Subject: Duke Energy Carolinas, LLC  
Catawba Nuclear Station Units 1 and 2  
Docket Nos. 50-413 and 50-414  
Emergency Plan, Revision 19-05

Enclosed for NRC Staff use is Revision 19-05 to the Catawba Nuclear Station Emergency Plan. This revision is effective as follows: Emergency Plan Section H, Rev. 150 and Section Q, Rev. 153 effective October 22, 2019; Emergency Plan Section M, Rev. 162 effective October 28, 2019; and Emergency Plan Section Q, Rev. 154 effective November 20, 2019. All changes have been specifically highlighted (side-barred). Also enclosed, are the §50.54(q) evaluations for the revision.

**Catawba Nuclear Station**  
**Attachment 1**  
**10CFR 50.54(q) Evaluations**

EMERGENCY PLAN CHANGE SCREENING AND EFFECTIVENESS EVALUATIONS 10 CFR 50.54(Q)	AD-EP-ALL-0602
	Rev. 6

Figure H-8, Catawba Nuclear Site Generalized MET System, does not appear in revision 2 of the Catawba Emergency Plan.

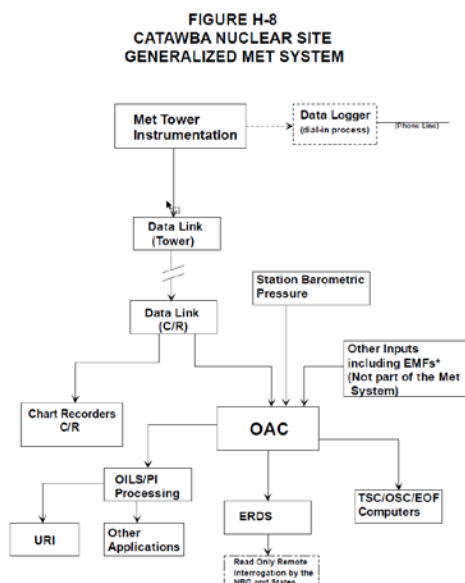
Figure H-8 is included in the current revision of Section H of the Emergency Plan (rev 149), as a block diagram, and "Chart Recorders C/R" is included as a block in the block diagram, seen below:

The change from analog chart recorders to a digital chart recorder was complete under EC 104554, 6/26/2013, without a 10 CFR 50.54(q) evaluation done. NCR 02297720 was written to document that the change was not evaluated prior to implementation.

The change from two analog chart recorders to a single digital recorder for Meteorological Data has not been a reduction in effectiveness of the Emergency Plan.

**FIGURE H-8  
CATAWBA NUCLEAR SITE  
GENERALIZED MET SYSTEM**

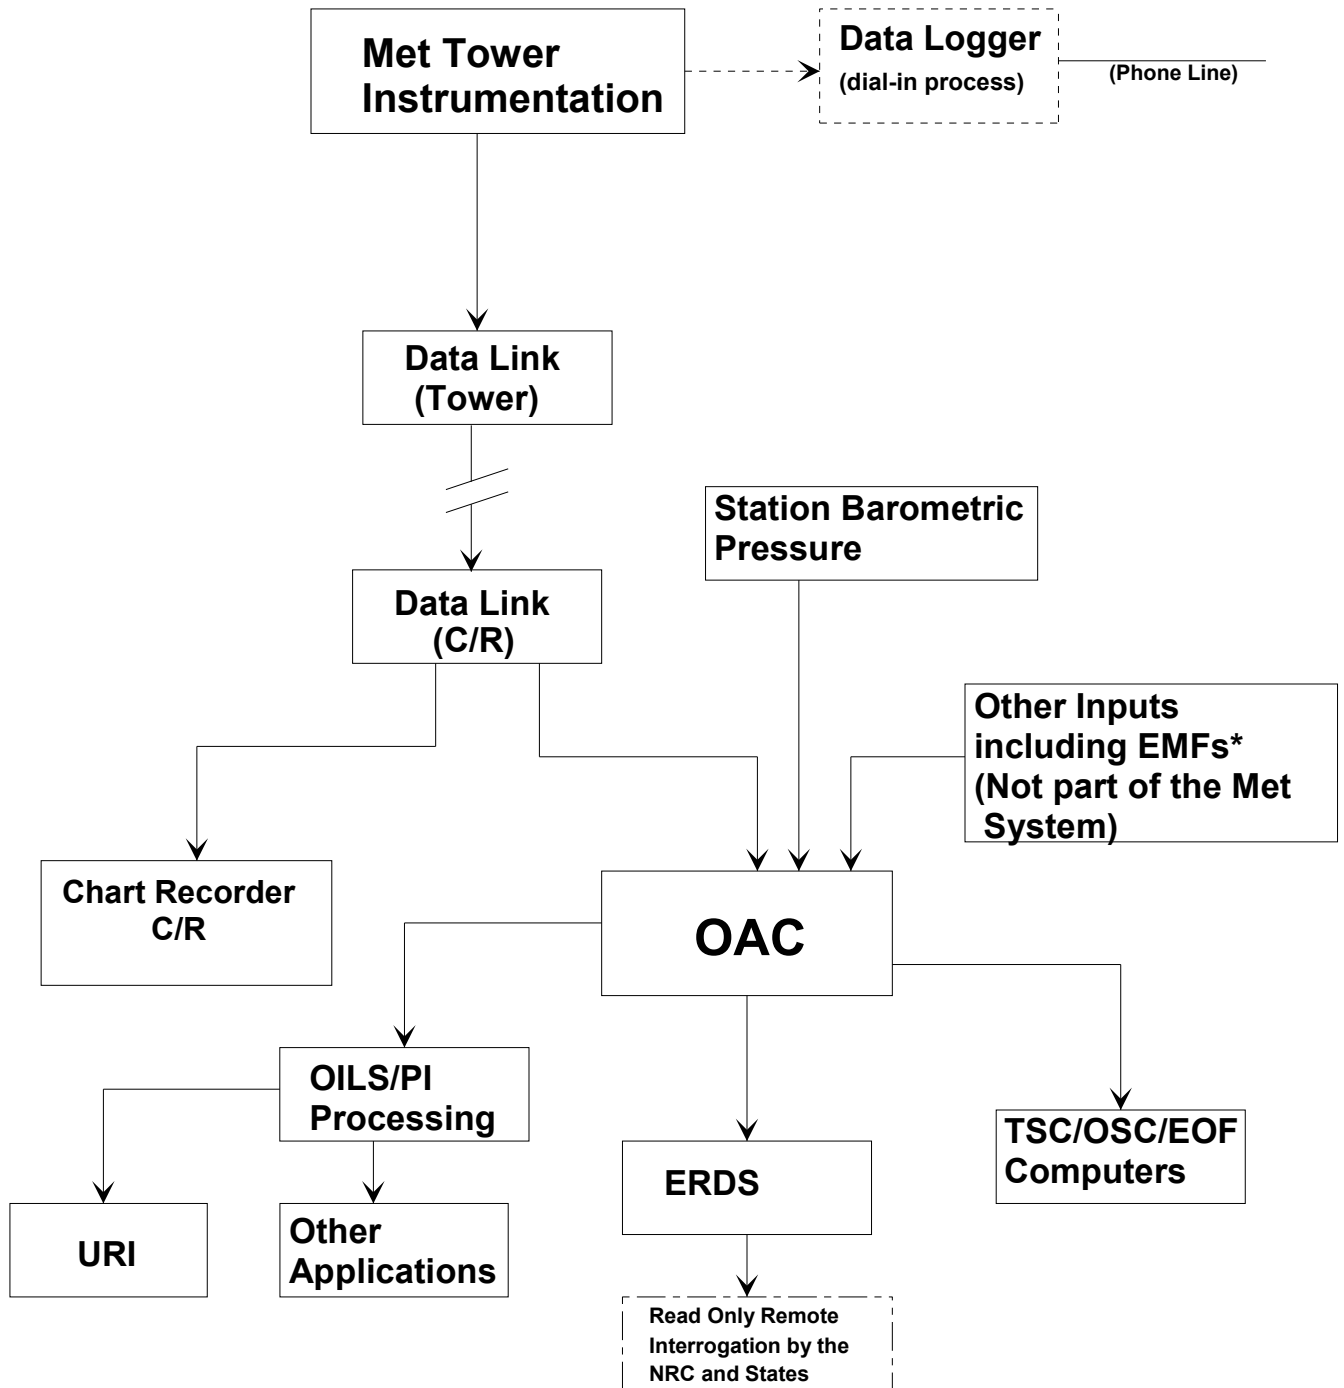
"0 EEB CR 5010 and 0 EEB CR 5020 are Westronics 3200 Chart Recorders which record the inputs from the Meteorological (MET) Tower. These recorders are of the older, analog type which use chart paper as a storage media. Both instruments have a history of failures which force the plant into a seven day action per SLC 16.7-3. In order to increase reliability of this sector of the overall EEB (Meteorological) System, these two recorders will be replaced by a single Thermo Electron SV180 Paperless Data Acquisition System.
